UNC Wilmington Alderman and King Hall Renovation

SCO ID#: 22-24639-01A

Addendum Number 4: August 30th, 2023

Project: UNCW King Hall Renovation
601 Hamilton Drive
Wilmington, NC 28403

ATTIC AND ROOF
DEMOLITION PLAN

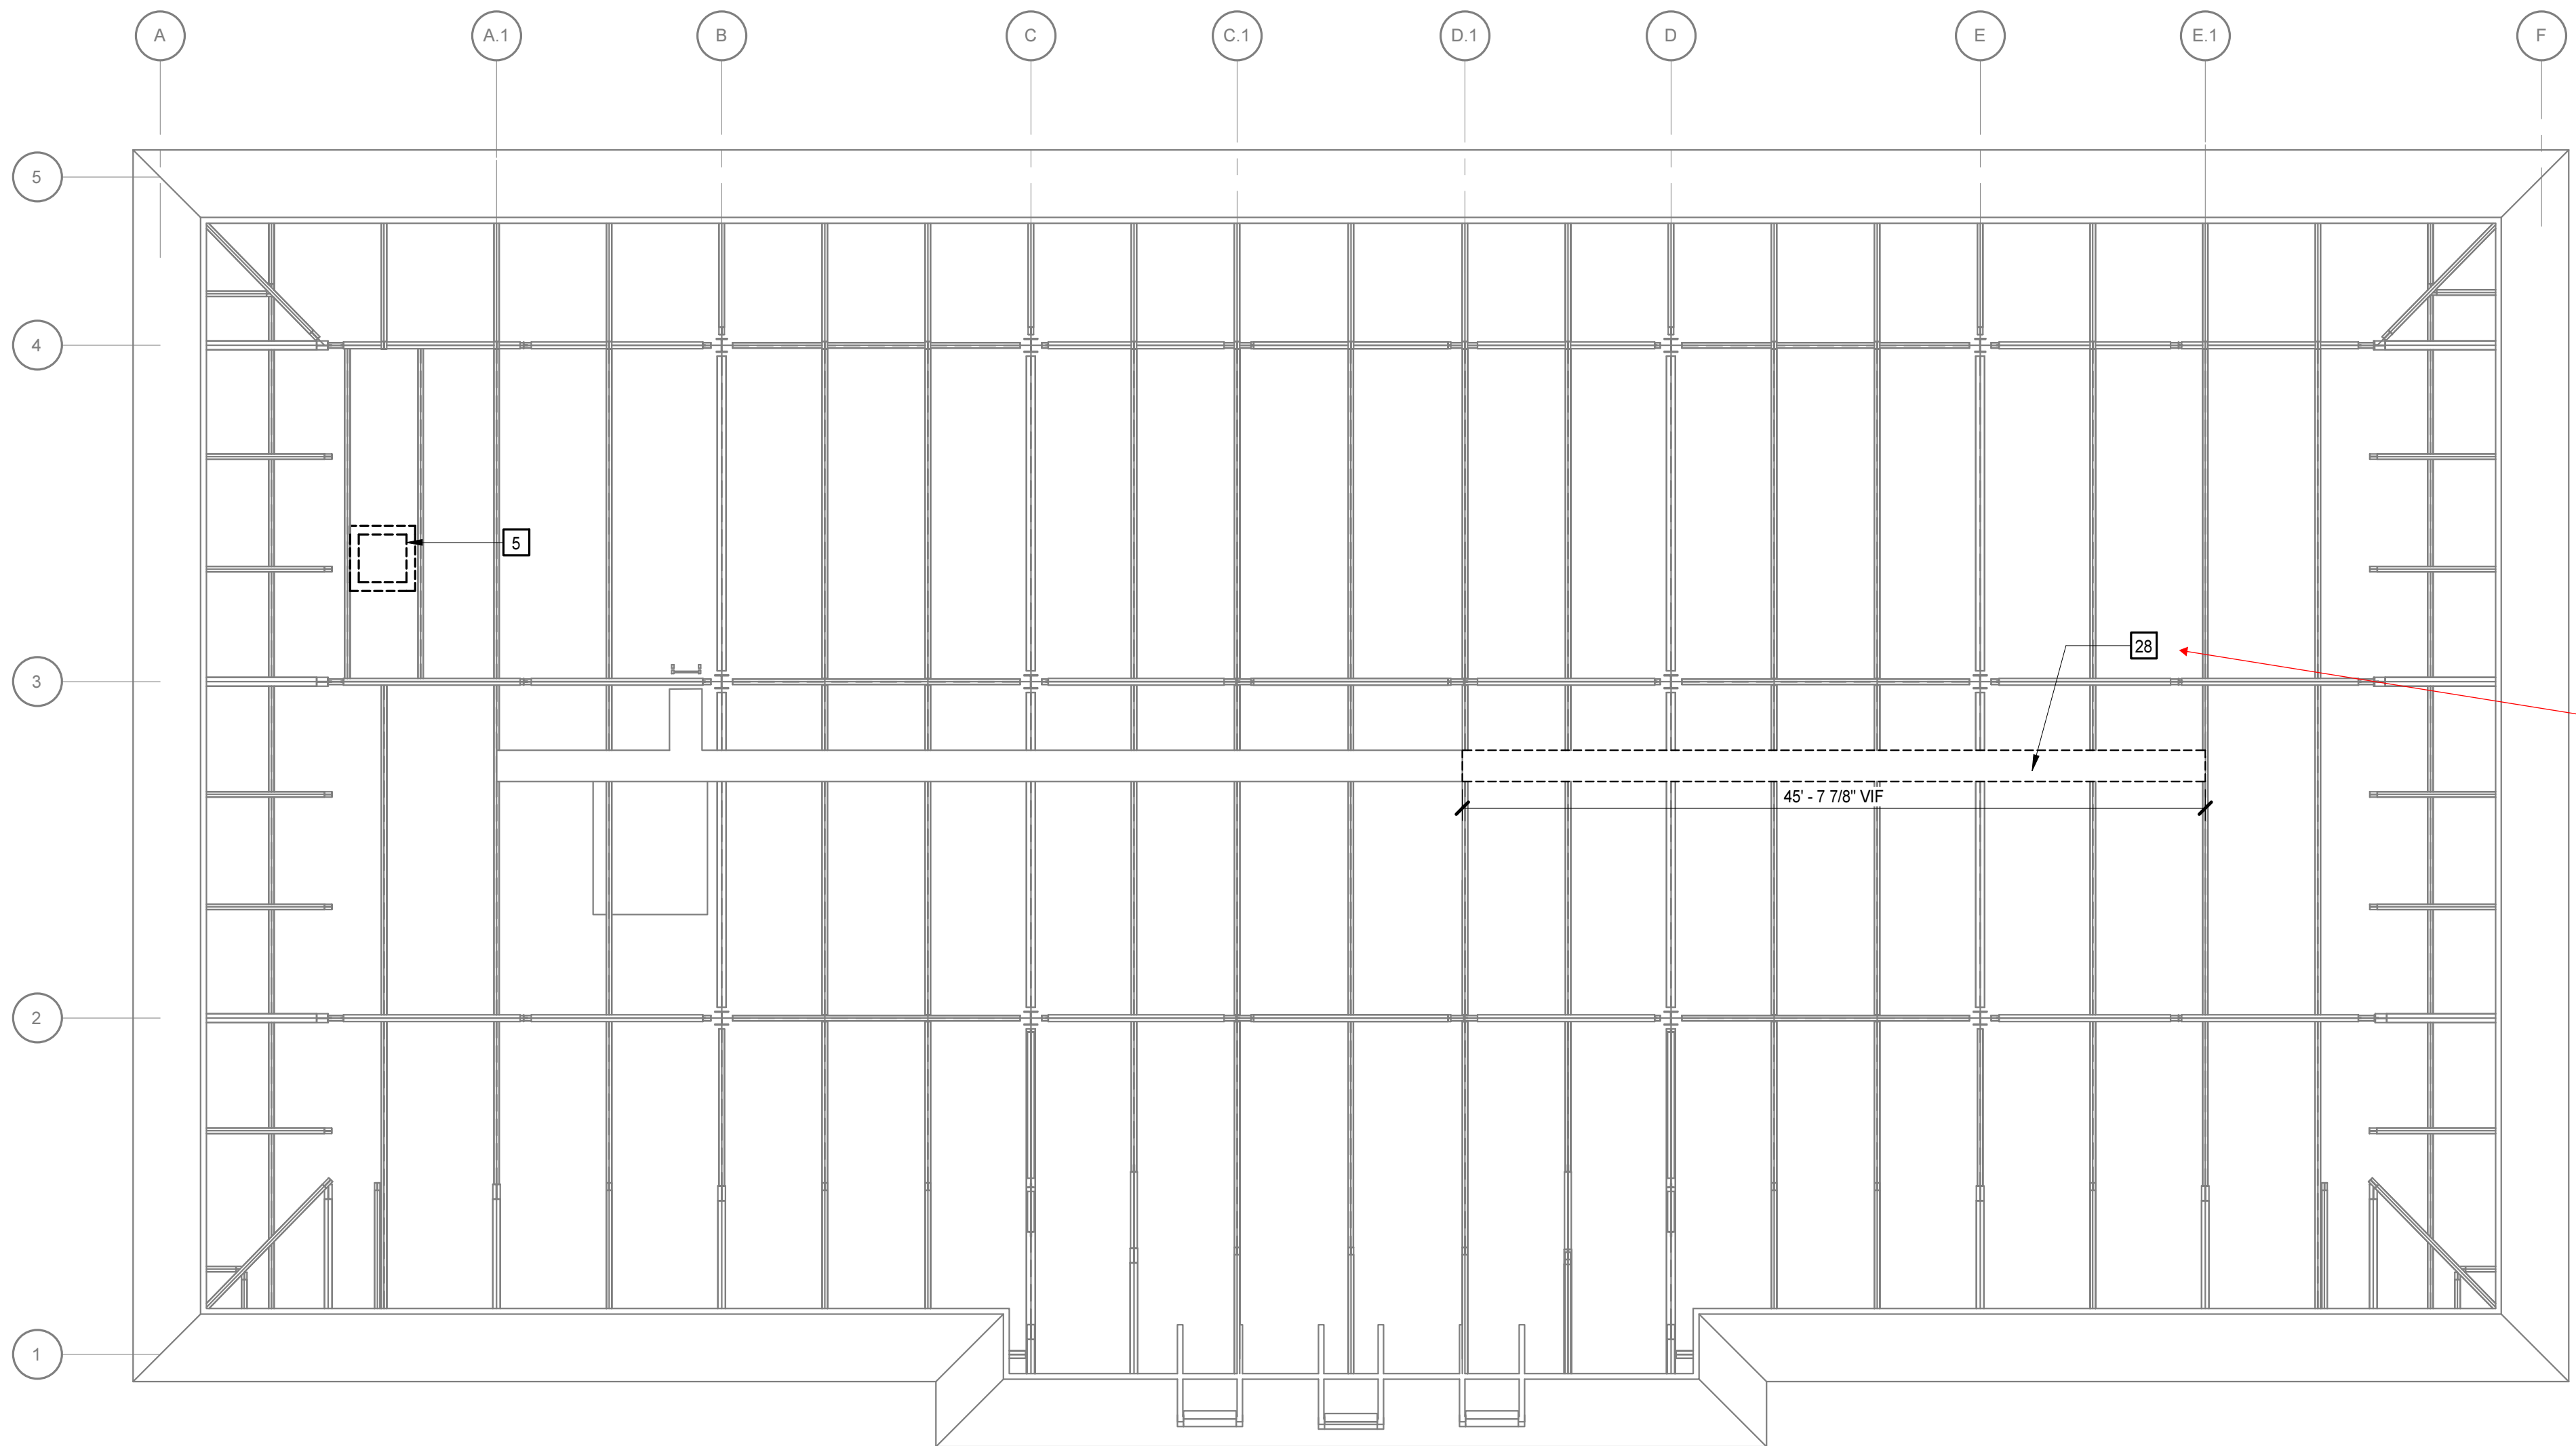
h. **Question:** Sheet A1.2 has a Keynote #28 but there is no description. Please clarify.

Answer: Keynote #28 indicates: "Remove existing catwalk". Please reference attached Sheet A1.2_ATTIC AND ROOF DEMOLITION PLAN Rev.4 markup

28 Demo existing catwalk

ATTIC & ROOF PLANS

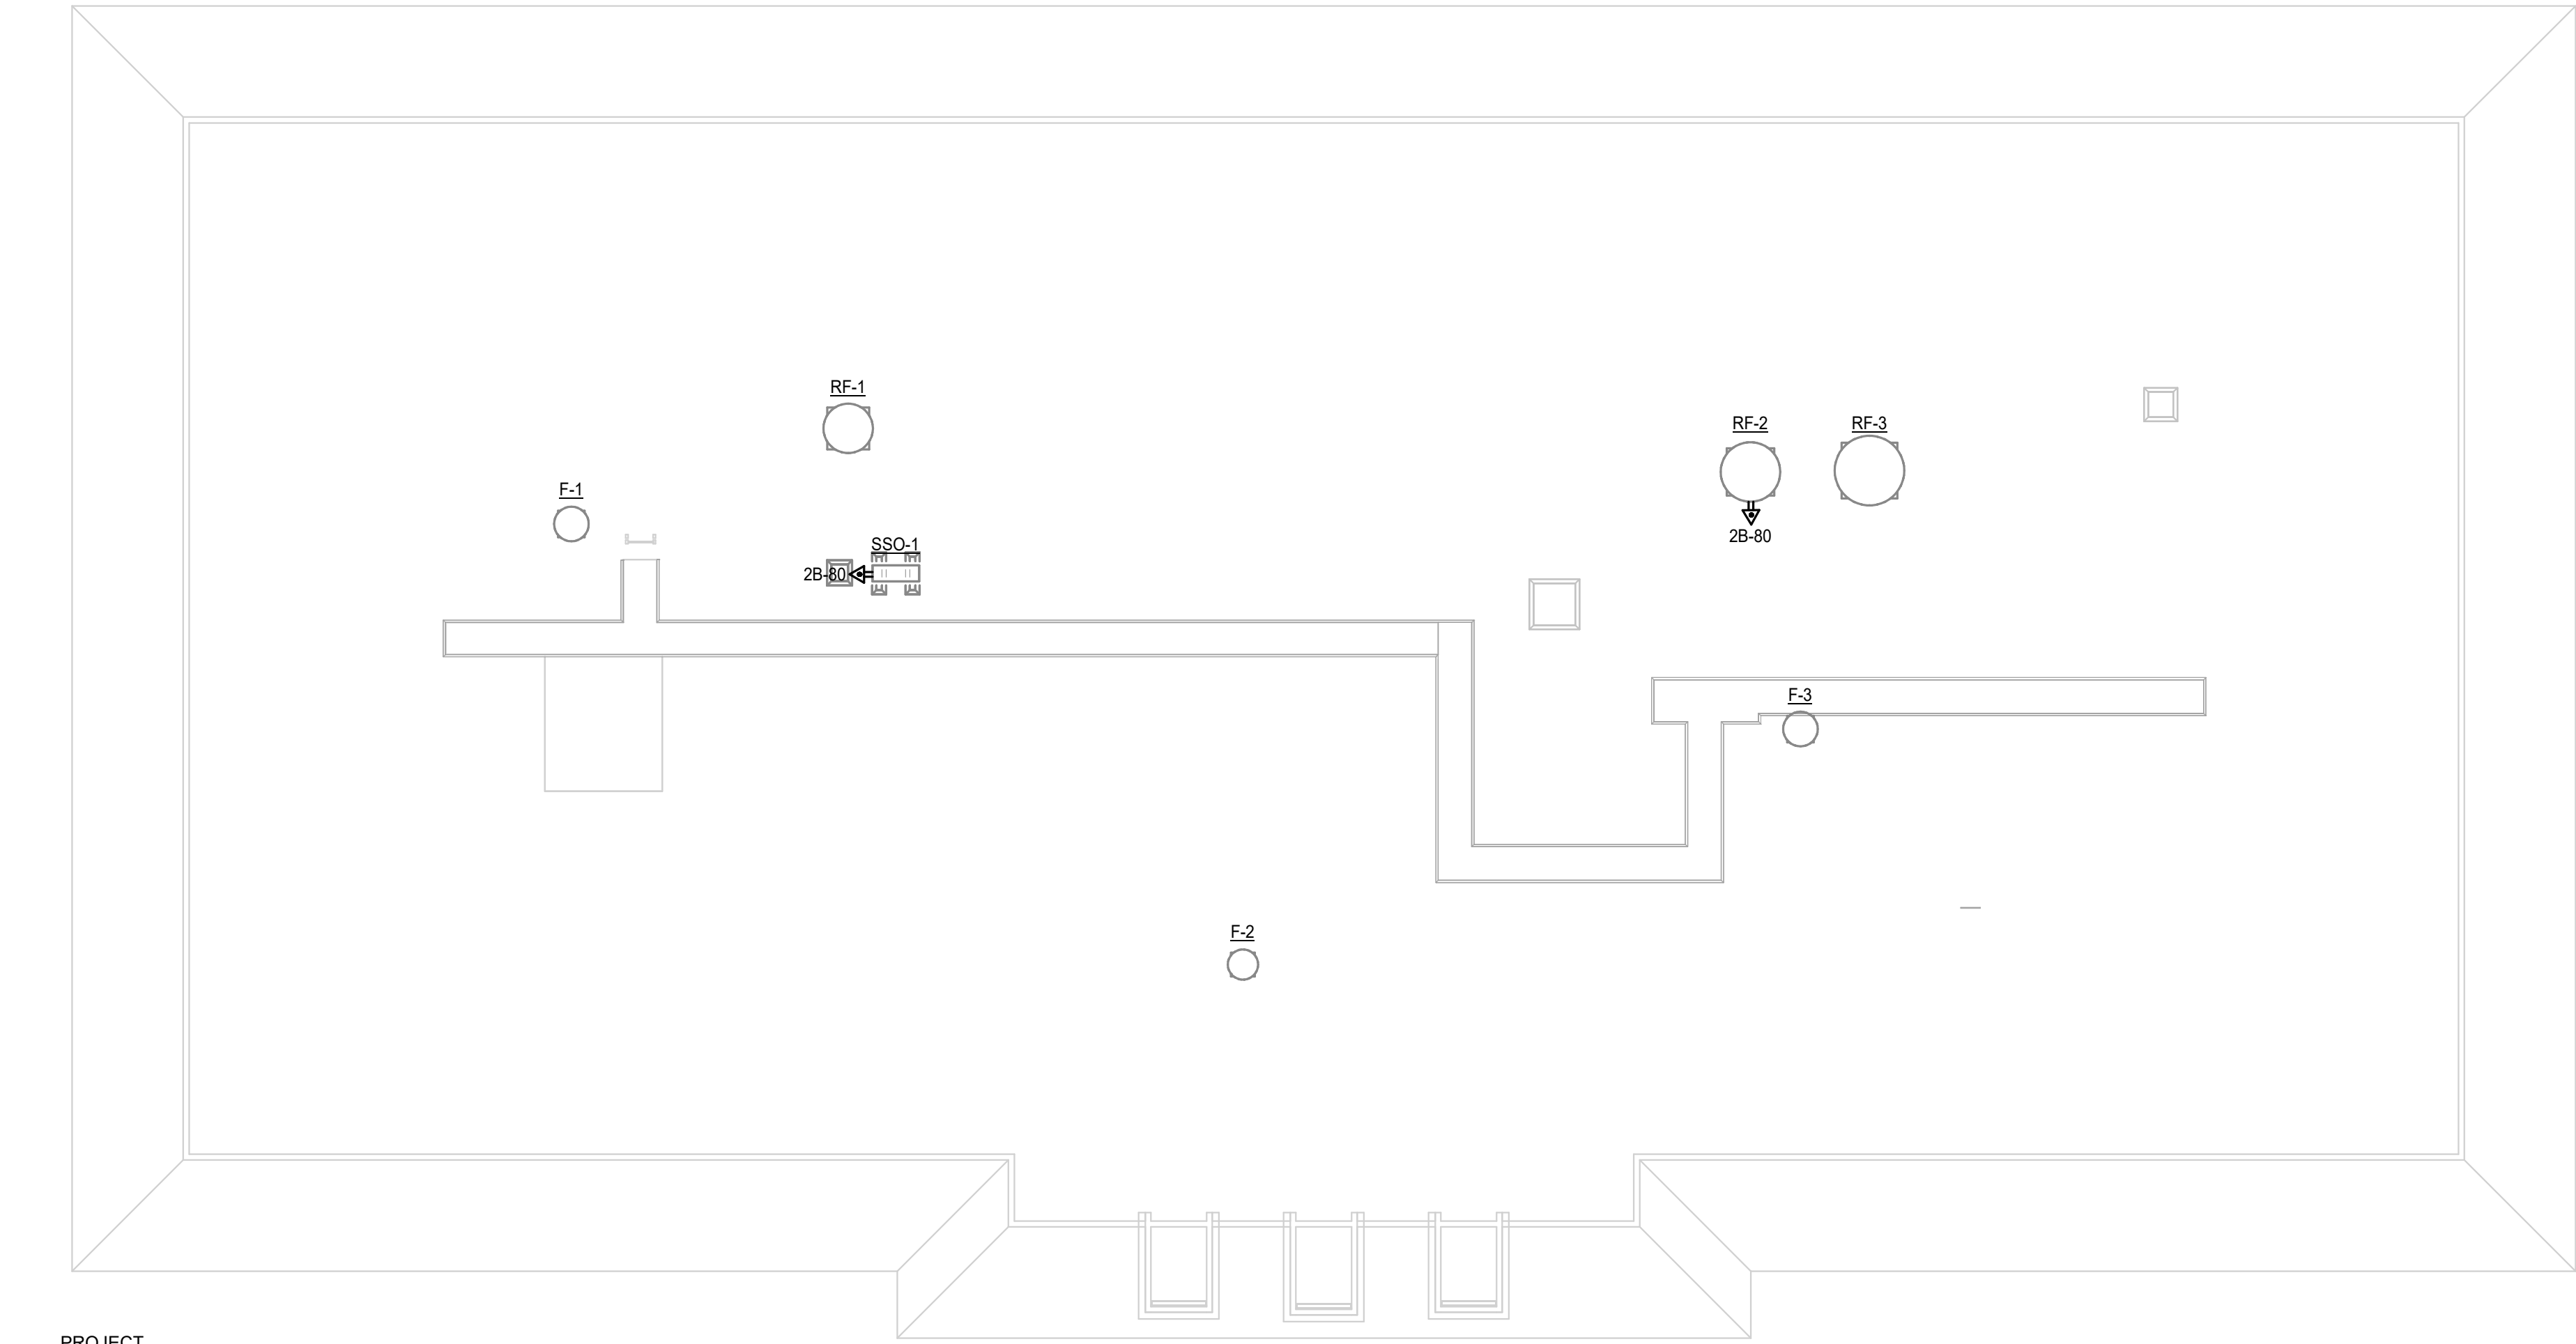
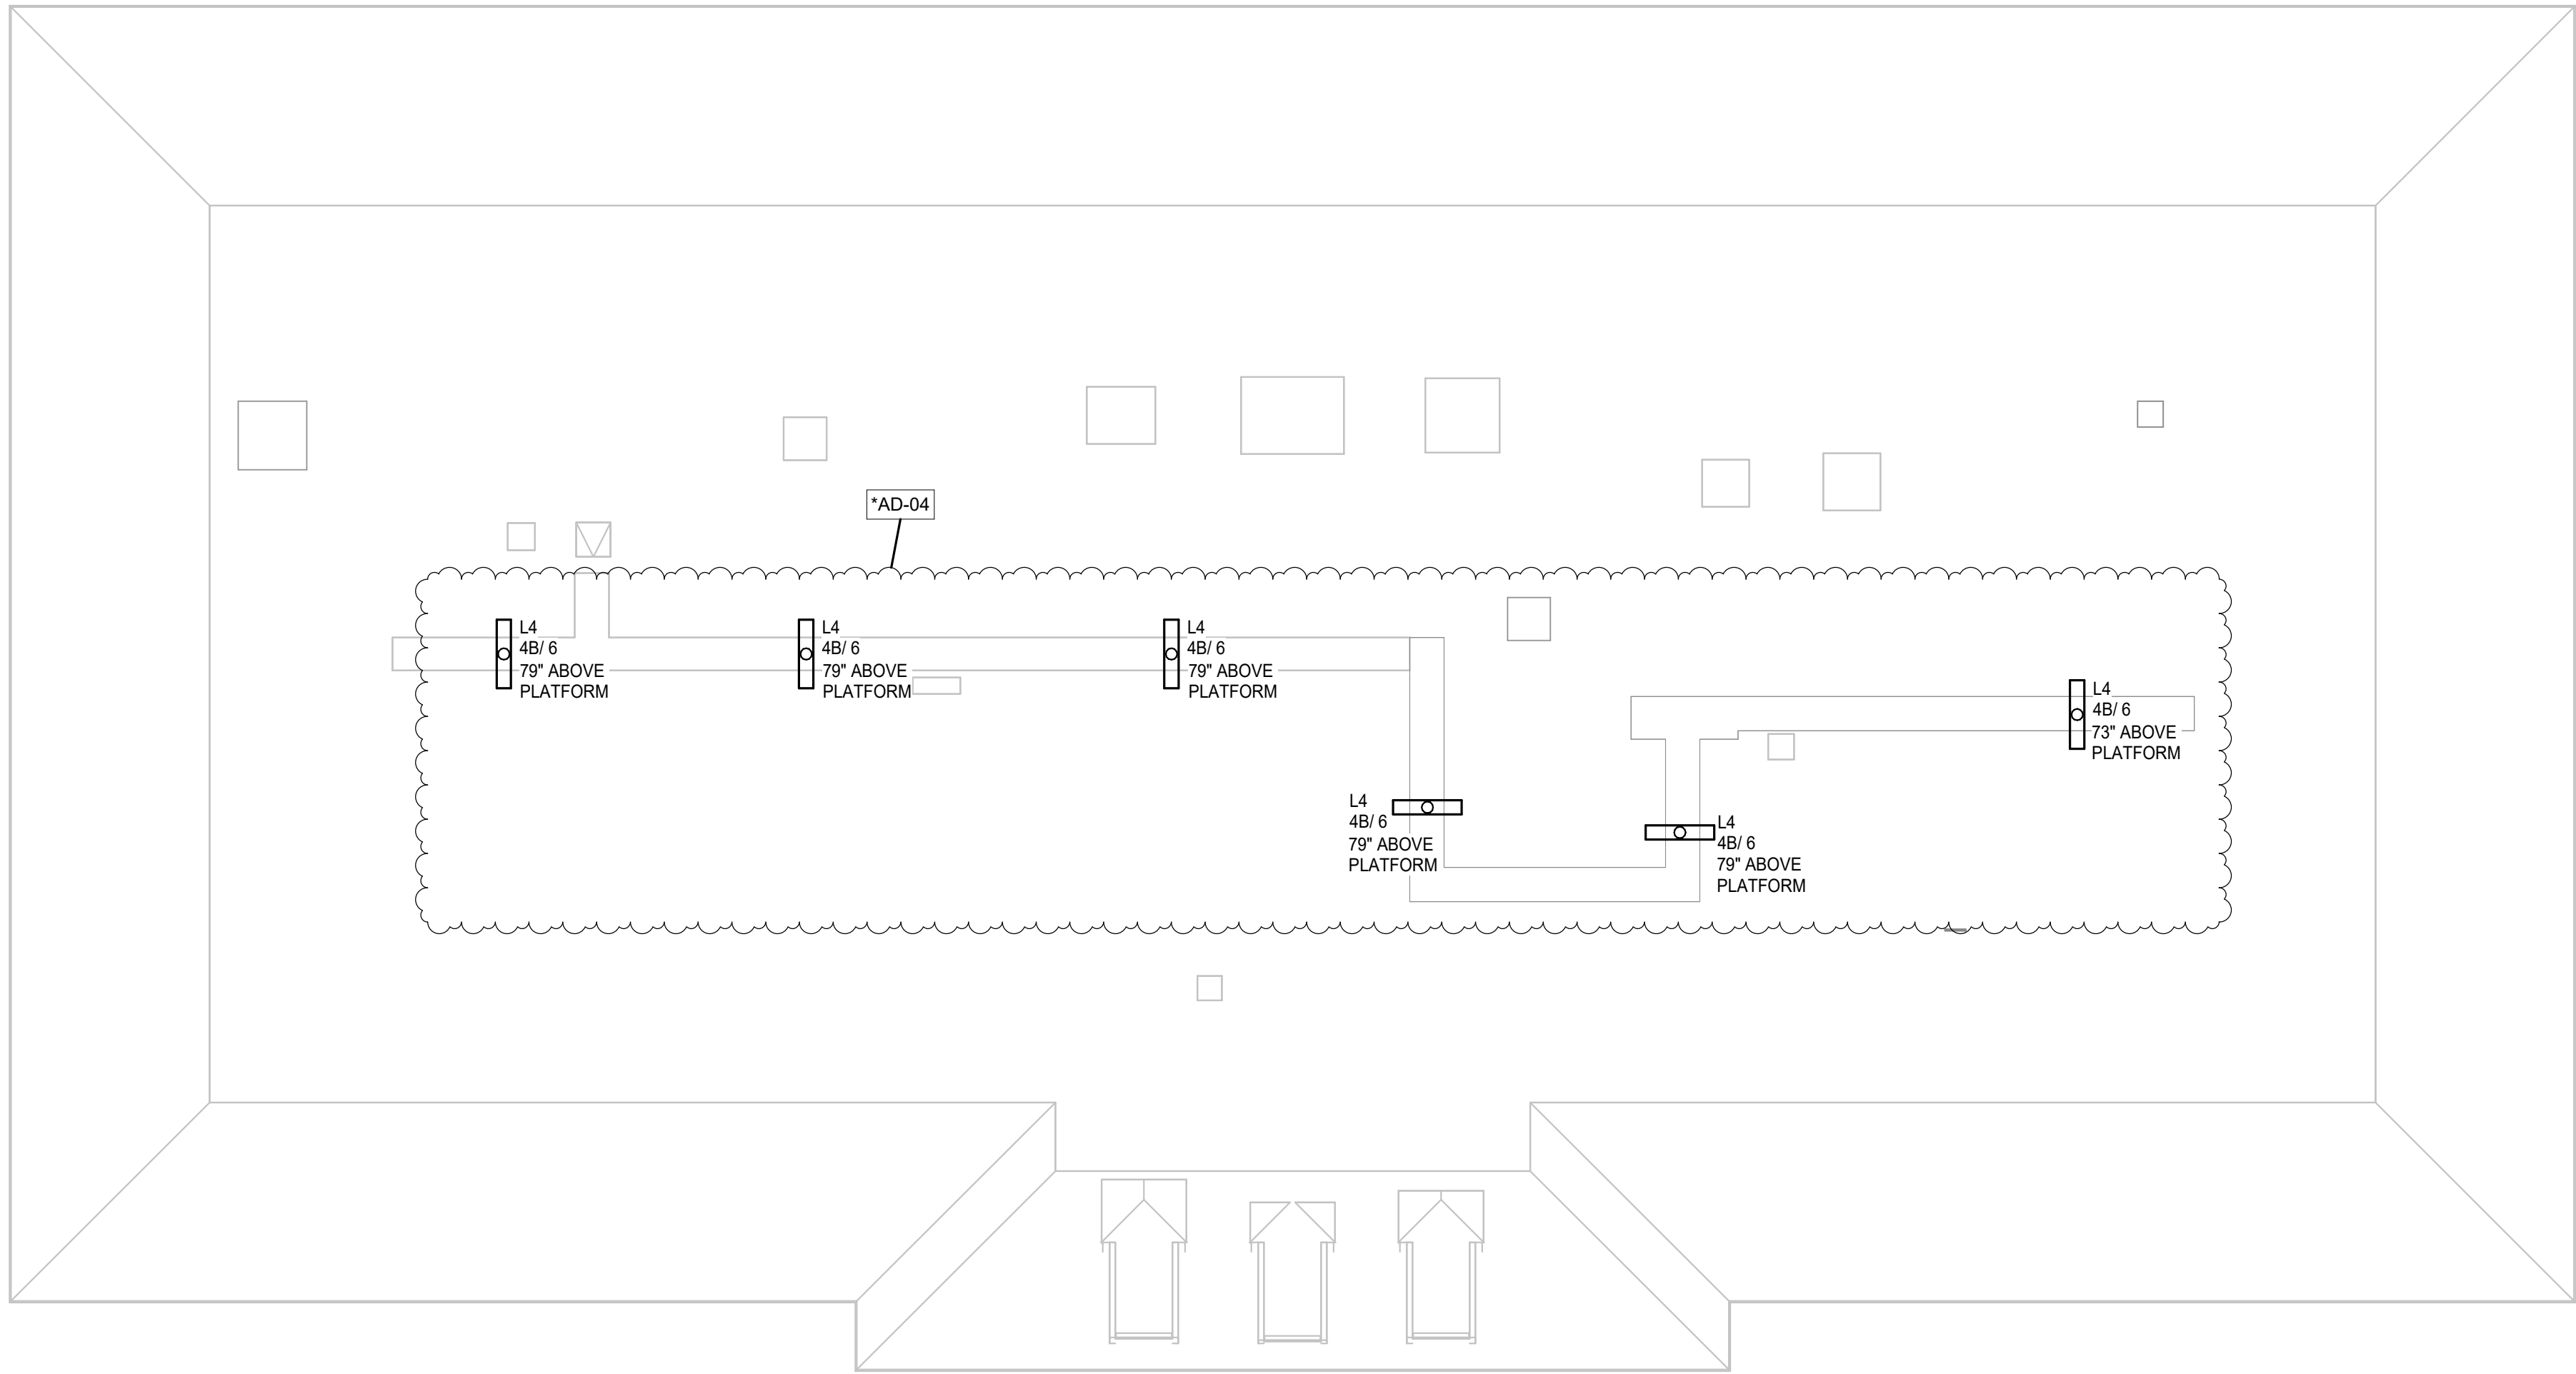
- g. **Question:** Attic Plan shows an L4 type fixture being installed in the attic on E2.1.1. to be clear are these new fixtures? What height would they need to be installed. It appeared

there is quite a bit of distance from floor to bottom of roof. There is no note on E2.1.1 about existing or new, so hard to know how to price.

Answer: Sheet E2.1.1 was replaced by Sheet E2.3 ATTIC ROOF PLAN as noted in Addendum No 1. These are new fixtures. Please see attached updated Sheet E2.3 ATTIC ROOF PLAN for mounting heights.
